2638C AND 2639D TELEPHONE SETS

1.001 This addendum supplements Section 502-612-405, Issue 1.

1.002 This addendum is issued to:

Fig. 1—2638C and 2639D Telephone Set, Connections

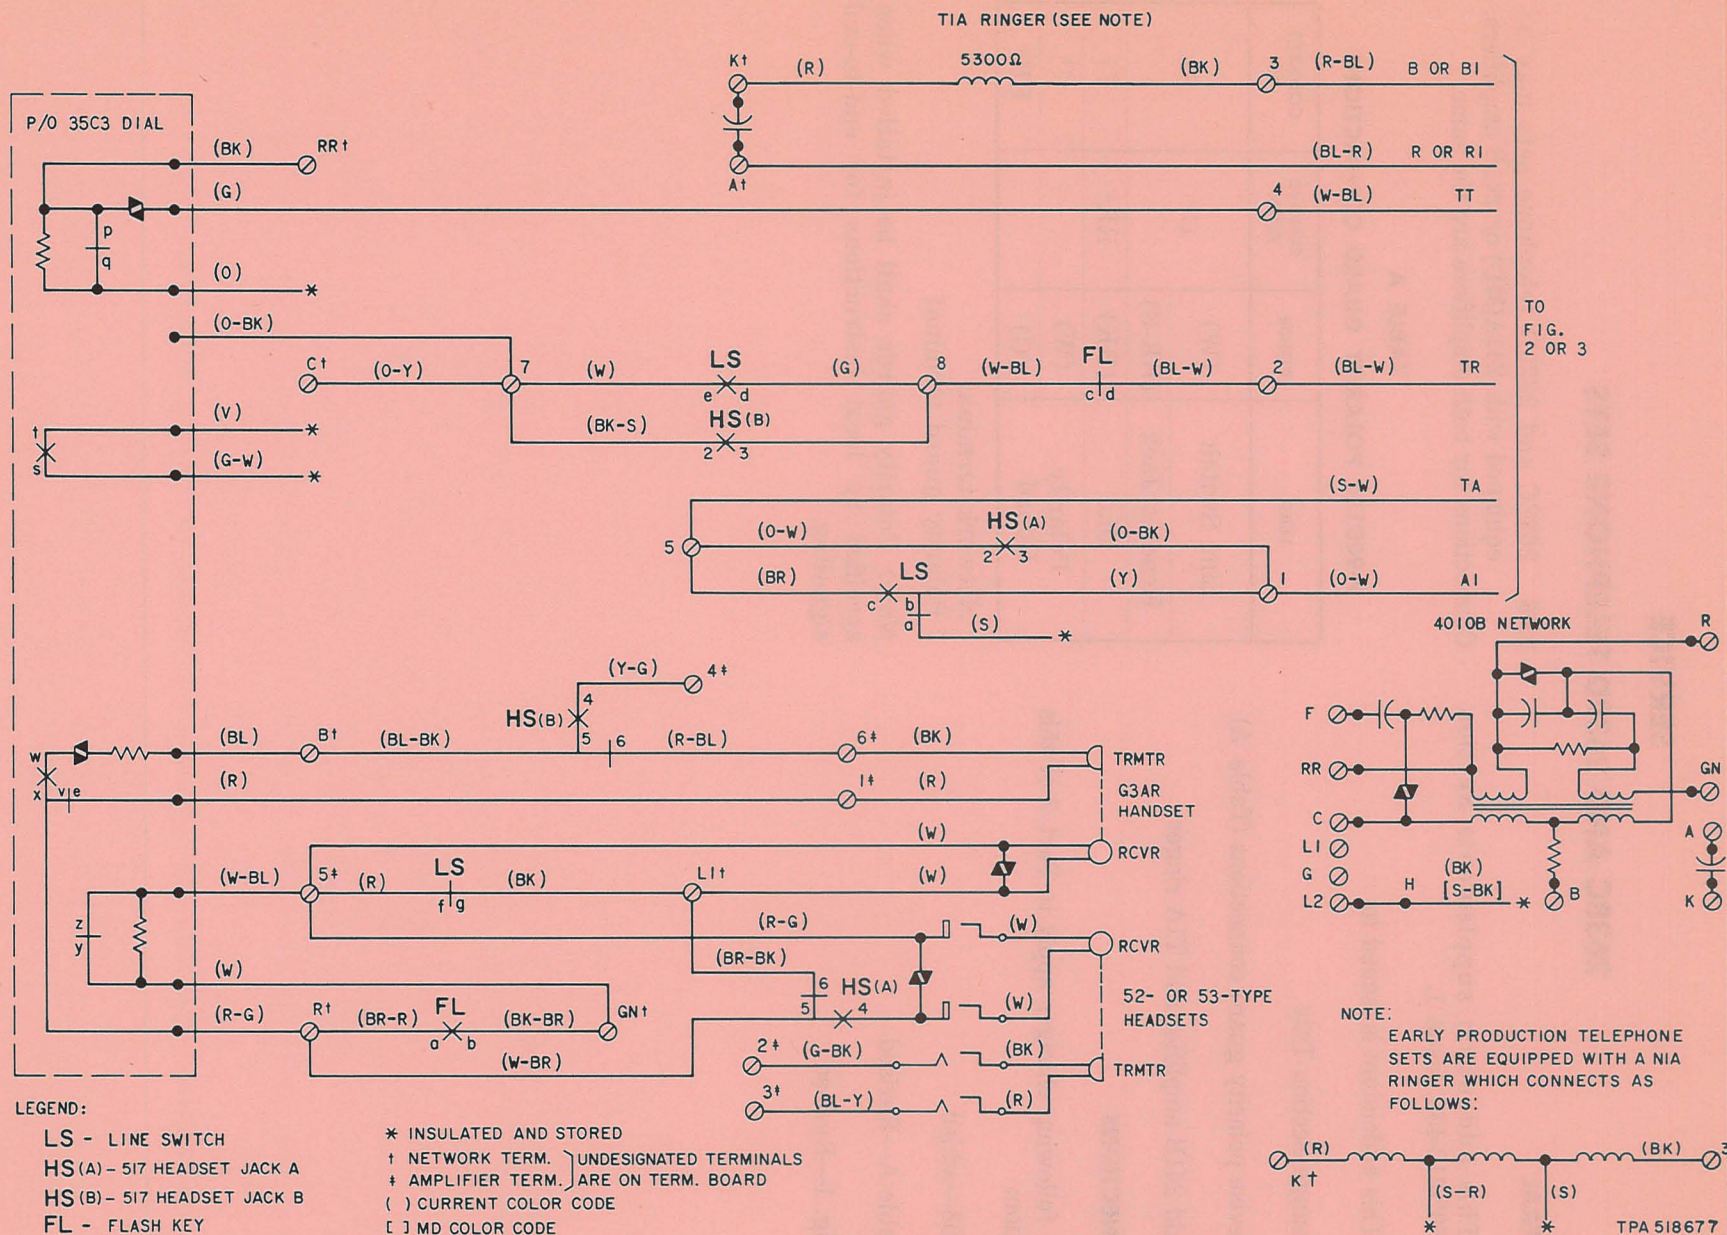
- (a) 2.08—added
- (b) Table A—Revised
- (c) Fig. 1—Revised

2.08 2638C and 2639D telephone sets may be equipped with 241A(MD) or 241B amplifiers. Connections for both amplifiers are the same.
